CITY OF SEASIDE
BOARD OF ARCHITECTURAL REVIEW

**CITY OF SEASIDE
STAFF REPORT**

SUBJECT: **Architectural Review Application No. BAR-16-02: Martin Morales (Property Owner) and Sergio A. Vaca, (Applicant) request approval to demolish an existing one-story residence and construct a new 1,776 square foot, two-story single-family dwelling, a new single-story 441 square foot two-car detached garage and associated site and landscape improvements at 1098 Clementina Avenue, located in the RH, High Density Residential, Zoning District.**

Conditions of Approval
File No. BAR-16-02
June 1, 2016

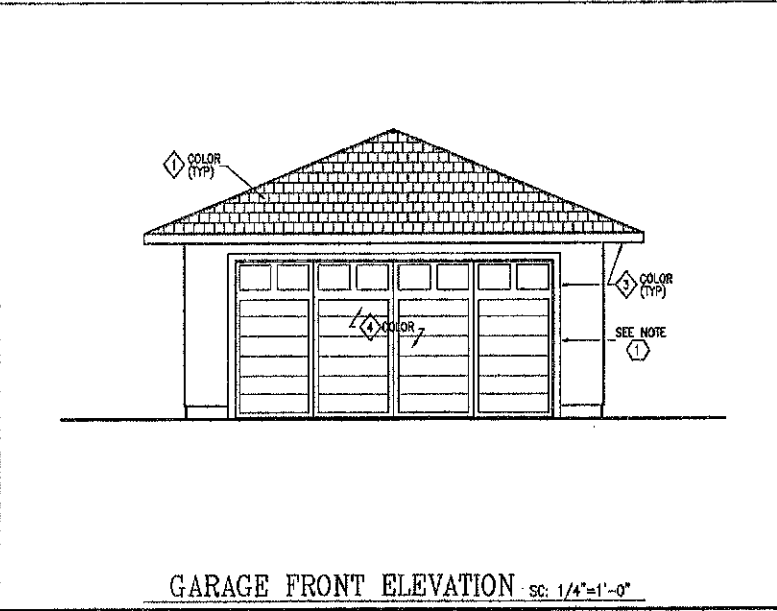
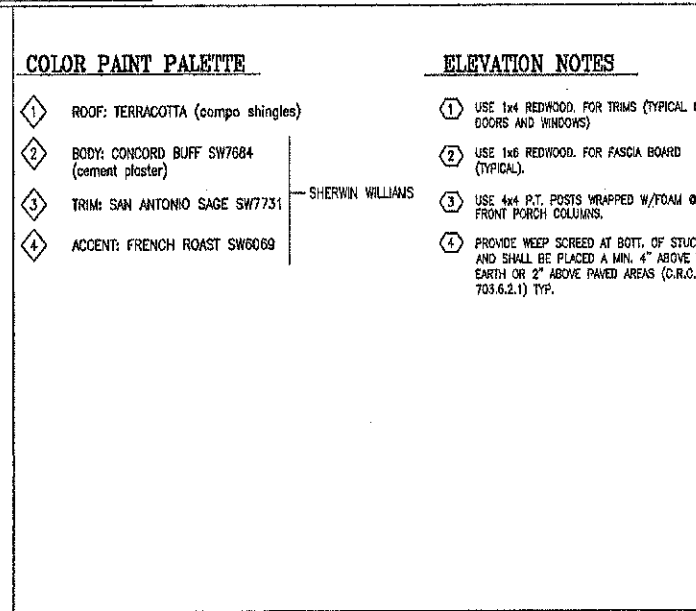
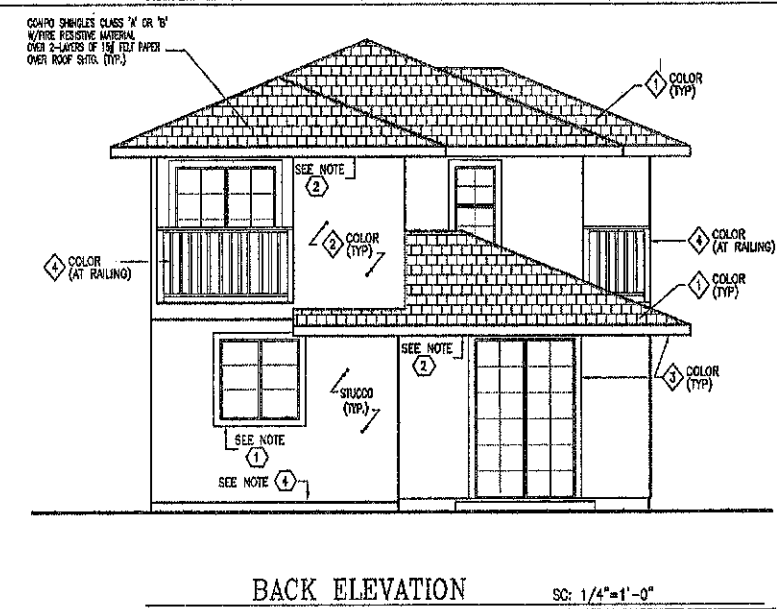
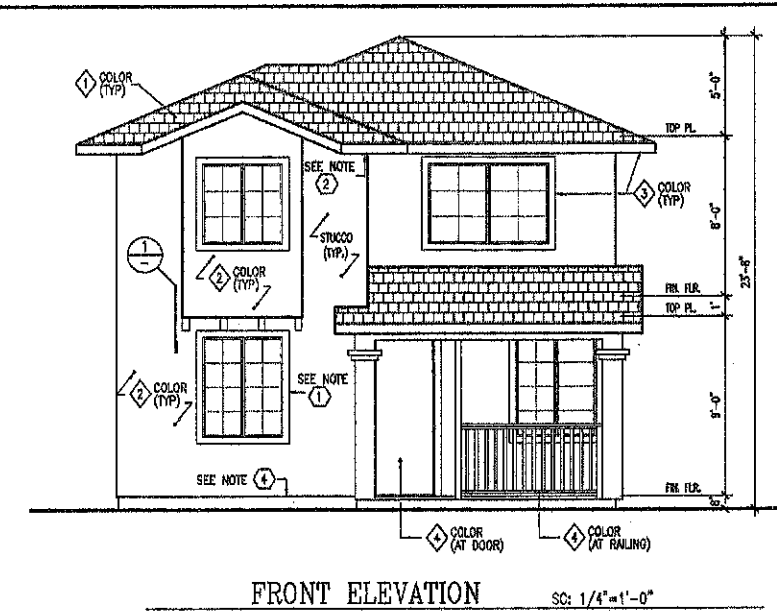
Response: The project proposes a variety of native, draught-tolerant and colorful plantings including California poppy, Douglas Iris, Mexican Sage, and three 15-gallon Western Redbud trees. Staff is recommending, as a condition of approval, alternative plant selections to replace the Meadow Sedge, Stonecrop and Red Twig Dogwood which are not on the draught-tolerant plant list in the Seaside Design Guidelines.

The landscape plan proposes approximately 190 square feet of “Natural” turf in the front yard.

Staff could not find a reference to that grass type and recommends the use of an ornamental, no-mow grass, such as Blue Lyme, California Fescue or Pacific Hairgrass. Staff also recommends that the curved front walkway be simplified with less-dramatic curves to improve use and ease landscape maintenance. The plan does not show any landscape materials within the five (5) foot west side yard. This area is integral to the site's stormwater and drainage management and needs to remain free of impervious surface. Conditions of approval in the proposed resolution (Exhibit A) include these landscape elements as requirements.

2. Plans submitted for Building Permit shall include the following revisions from the attached, Exhibit A, Architectural Review plans:
 - a. The plant list shall be revised to eliminate the California Meadow Sedge, Stonecrop, Red Twig Dogwood and Natura Turf and include alternative drought tolerant plantings and turf.

- b. Site and landscape plans shall be revised to show a pervious path of travel from the rear sliding door to the rear garage door.
 - c. The new front yard entry walkway shall be redesigned with a more subtle curve to improve pedestrian usability and landscape maintenance.

SHEET TITLE FIRST FLOOR PLAN SECOND FLOOR PLAN	DATE	SEP-2015	KEY ▲ ▲ ▲ ▲ ▲
	SCALE	AS NOTED	
DRAWN	S.V.		
JOB	15-10		
SHEET	A2		
OF SHEETS

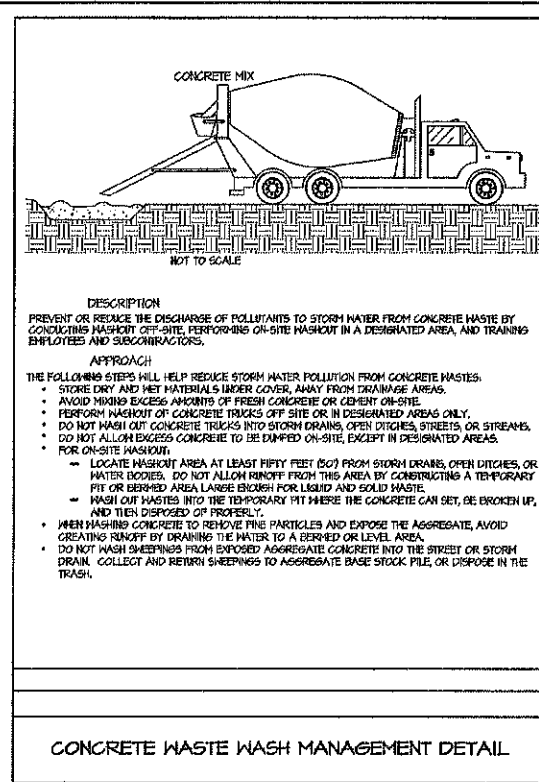
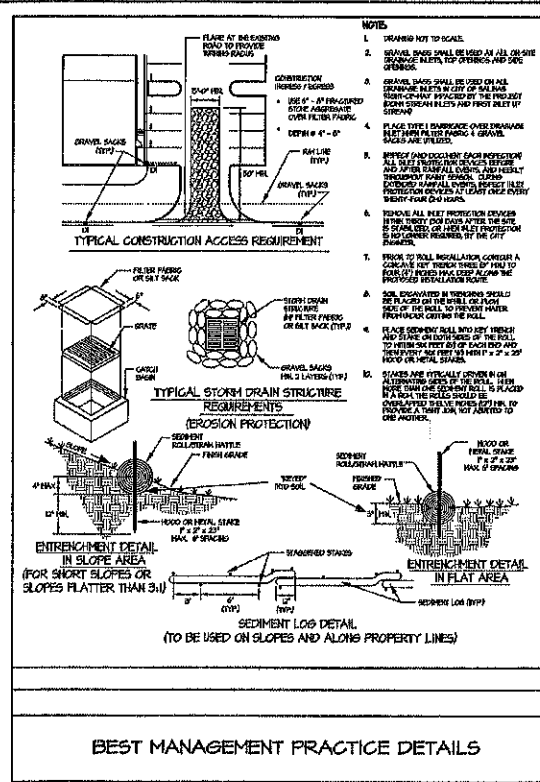
Staff recommends that a pathway from the rear sliding door of the home to the garage entry man-door be improved with pervious pavers or stepping stones to enhance the pedestrian connection between the two structures. Staff also suggests that the second, west-facing balcony incorporate screening, such as solid railings, to enhance privacy.

Response: Exterior lighting will be consistent with standard residential lighting. Staff is recommending as a condition of approval that the large stairwell window on the right (west) elevation be reduced in size and fitted with frosted or decorative glazing to reduce potential light intrusion onto the neighboring multi-family development. Staff believes that other second story windows will not pose a significant privacy or light impact on neighbors in that the proposed windows are in upstairs bedrooms which typically have window coverings and are not gathering areas. Staff is also recommending that lighting in second story balconies be recessed and have shielded light sources to prevent off-site glare. Staff believes that as proposed and conditioned, the exterior lighting will be sensitive to surrounding residences.

- e. The second floor stairwell window on the right (east) elevation shall be reduced in size and use decorative or frosted glass to reduce potential light intrusion on neighboring properties.

- f. The second story west-facing balcony shall be designed with solid railings to enhance privacy.
3. All exterior lighting shall be down-directed with shielded light sources to prevent glare and/or light intrusion on neighbors.
